Planning Officer's Report – LDCA NOVEMBER 2025

APPLICATION	2025/82 – Proposed Security Fence
PERMISSION SOUGHT	Full Permission
REGISTERED	09 September 2025
APPLICANT	Jill Bolton
PARCEL	JT020034
LOCALITY	The Coffee Shop, Jamestown
ZONE	Intermediate
CONSERVATION AREA	Jamestown Historic
CURRENT USE	Coffee Shop
PUBLICITY	The application was advertised as follows: <ul style="list-style-type: none"> ▪ The Sentinel Newspaper on 11 September 2025. ▪ A site notice displayed in accordance with Regulations.
EXPIRY	25 September 2025
REPRESENTATIONS	Two received
DECISION ROUTE	Delegated / LDCA / EXCO

Diagram 2: Photographs Showing Current Picket Fence In-Situ

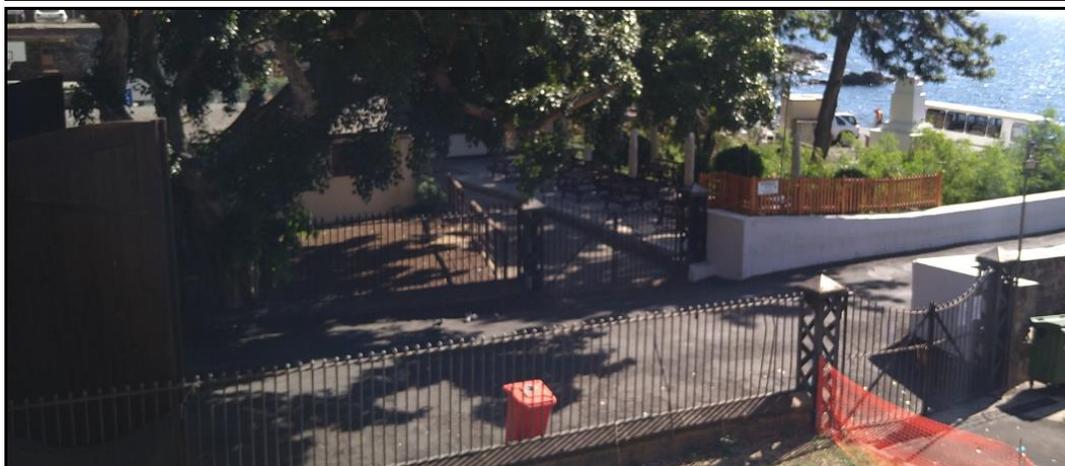
The current unauthorised picket fence has been installed within the grounds of *The Coffee Shop*, affixed on top of the boundary/heritage wall and protrudes above (see photographs below).

This current development application was registered on 9th September 2025 and therefore complies with being submitted within the 2 month period defined by the LDAT on 10th July 2025. As such, and in accordance with the above, the Enforcement Notice which requires the removal of the unauthorised fence will not be enforced until the 9th June 2026 at the earliest, although if a new fence is implemented then the unauthorised fence should be removed before that date.

Diagram 3: Site Plan Showing Location of Proposed Fence

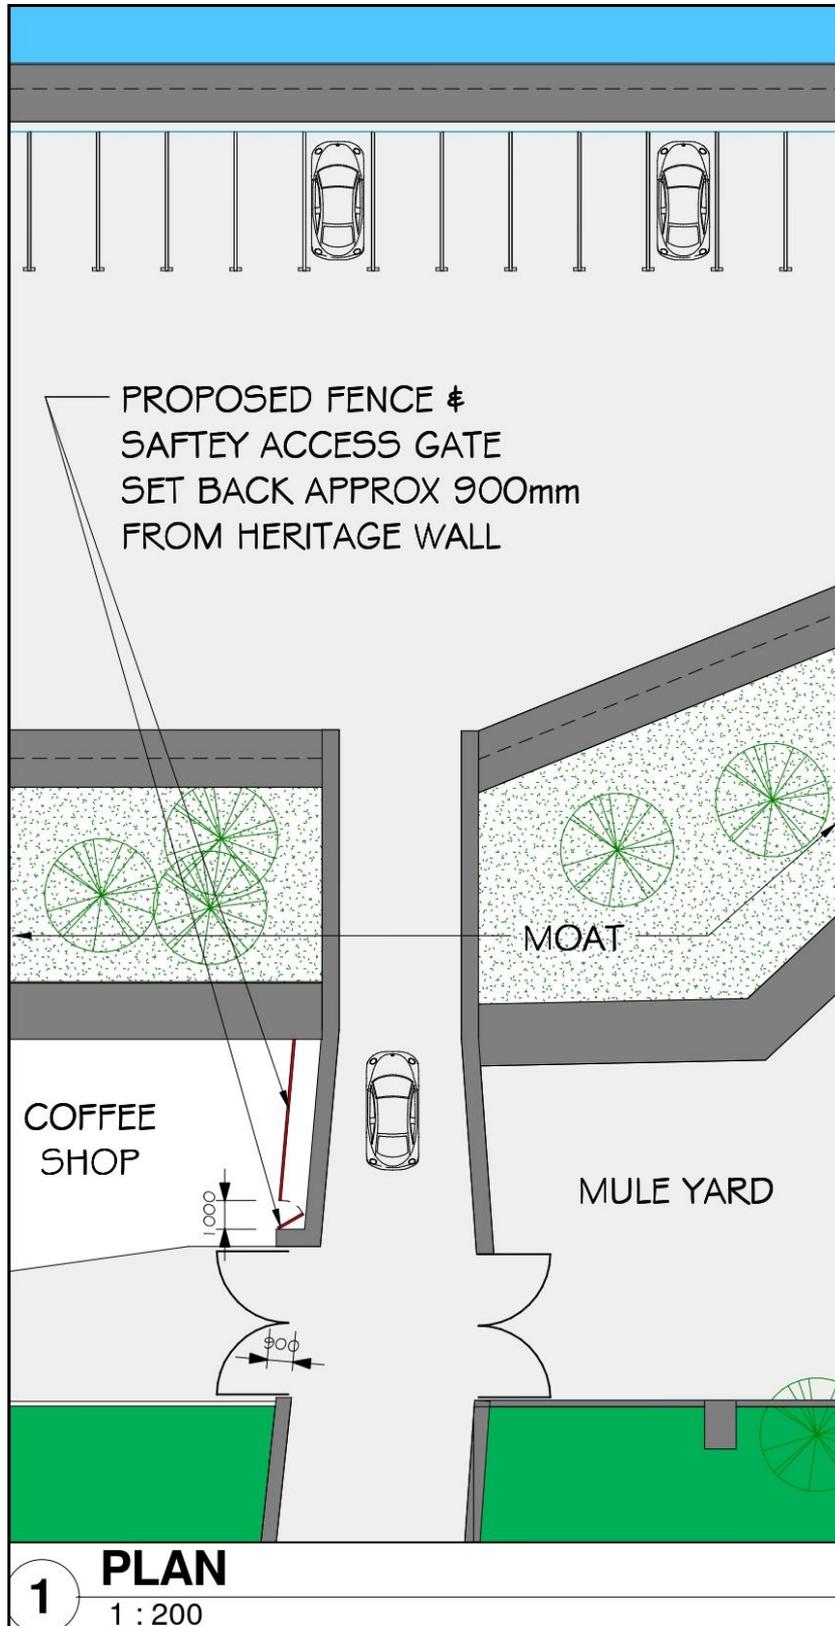
The application form says it is for a Proposed Security Fence. The accompanying drawing is confusing because it does not show just one proposed security fence. There is no detailed plan showing the proposal in relation to the existing lattice gate structure and no elevation from the west. There is no detail of how the proposed fence will be terminated against the moat.

However the proposed 2.9m high fence is well in excess of what the Police indicate would be needed for security purposes and furthermore, the proposed fence projects up over that of the historic boundary wall by more than a metre at the highest point and, although set back from the boundary wall by just under 1m (900mm) it will appear prominent and visible from public viewpoints in the surrounding streetscape such that this proposal to install a security fence consisting of chain link fencing is not in keeping with any of the heritage features that faces directly on to the streetscape.

Diagram 4: East Elevation Showing Chain Link Fence

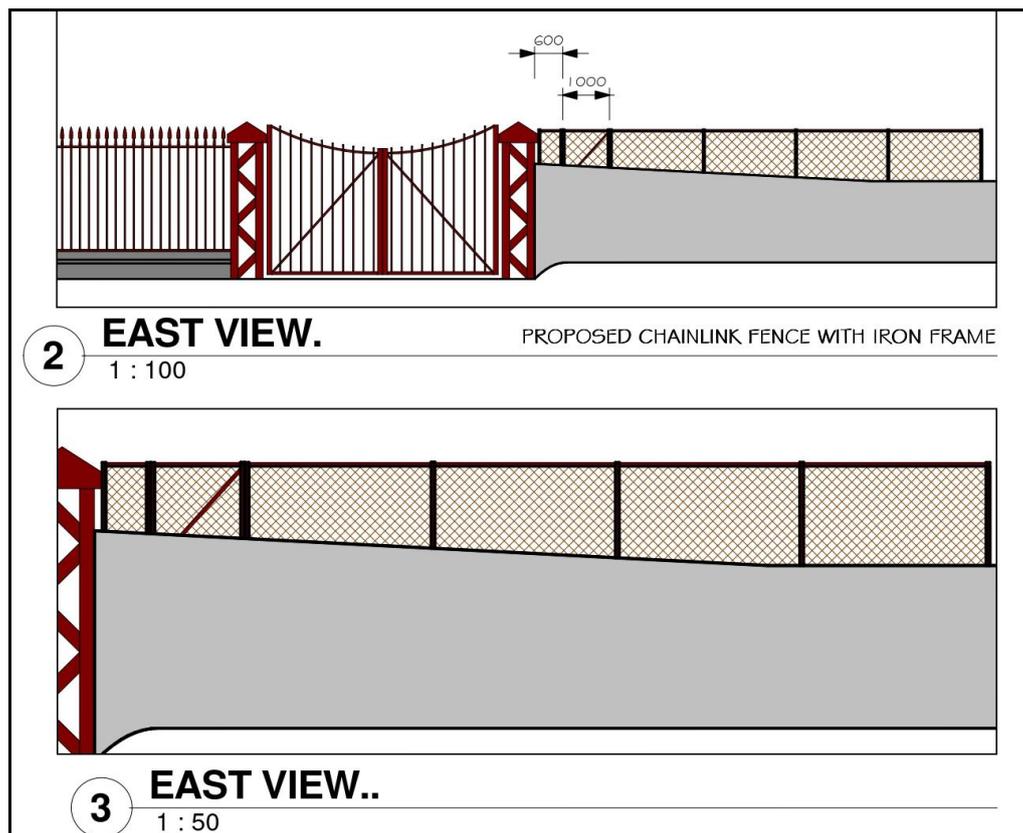
In considering the development proposal for a security chain link fence with iron frame, in accordance with the relevant policies, the design, material, scale and siting of the fence is not considered to contribute to the conservation of, nor enhances the aesthetic of the heritage streetscape of which it will be a part of, that is the bridge leading through *The Arch*.

Therefore, and to conclude this assessment of the proposal, the overall design of the chain link fence is not in line with LDCP Policies BH1 and BH2, in that it is not complimentary of existing features and does not add to the character or support the conservation of the Jamestown Historic area.

- 1) The development fails to comply with LDCP Policies BH1 a), BH1 c), BH.2 and BH5, as the appearance of the fence is not appropriate to the appearance and setting of the immediate area and Jamestown Historic Conservation Area, in terms of its design, scale, materials and siting.
